# UNITED STATES PATENT AND TRADEMARK OFFICE

APPLICATION NO.	FILING DATE	FIRST NAMED INVENTOR	ATTORNEY DOCKET NO.	CONFIRMATION NO.
10/632,545	08/01/2003	Michael F. Brletich	12539	2681
7590	09/12/2007		EXAMINER	
PAUL F. DONOVAN			GARCIA, ERNESTO	
ILLINOIS TOOL WORKS INC.				
3600 WEST LAKE AVENUE			ART UNIT	PAPER NUMBER
GLENVIEW, IL 60025			3679	
			MAIL DATE	DELIVERY MODE
			09/12/2007	PAPER

<b><i>Office Action Summary</i></b>	<b>Application No.</b>	<b>Applicant(s)</b>
	10/632,545	BRLETICH ET AL.
<b>Examiner</b>	<b>Art Unit</b>	
	Ernesto Garcia	3679

### **DETAILED ACTION**

FIG. 35

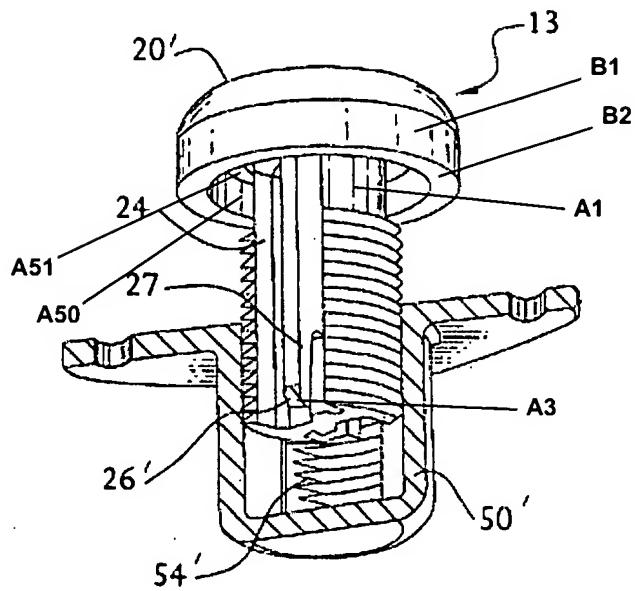
Regarding claim 9, Antonucci et al. disclose, in Fig. 35, a device comprising a fastener plug **13** including an end cap **20'** and at least one disc **28** spaced apart from the end cap **20'**. The fastener plug **13** defines a flexible extension member **27** extending outwardly from the end cap **20'** and across the at least one disc **28**. The flexible extension member **27** has a fixed end connected to the end cap **20'** and a free end opposite the fixed end. The free end includes an aperture engaging-member **26'**. The end cap **20'** defines a peripheral edge. However, Antonucci et al., fails to disclose a flat truncated surface along the peripheral edge. Applicants are reminded that changing the shape of the end cap to include a flat truncated surface is an obvious modification since changing the shape in Antonucci et al. is not critical to practicing the invention and one skilled in the art at the time the invention was made would have changed the configuration to a polygonal head or a non-round configuration to align the aperture engaging-member along the flat truncated member to locate the orientation of the aperture engaging-member as compared to the rib (unreferenced) on the end cap.

Regarding claim 1, the fastener plug **13** includes a plug portion **20'** and a fastener portion **24**. The plug portion **20'** defines the end cap **20'** and the at least one disc **28**. The fastener portion **24** defines the flexible extension member **27**. The end cap **20'** includes at least one retaining wall **A50** (see marked-up attachment) extending outwardly from an inner surface **A51** of the end cap **20'**. The projecting member **26'** is a projecting member.

Regarding claims 3 and 11, a rib **A1** (see marked-up attachment) connects the disc **28** to the end cap **20'**.

Regarding claim 7, the discs **28** define a flat surface edge **A2**.

Regarding claim 8, the projection member **26'** defines an inclined surface **A3**.
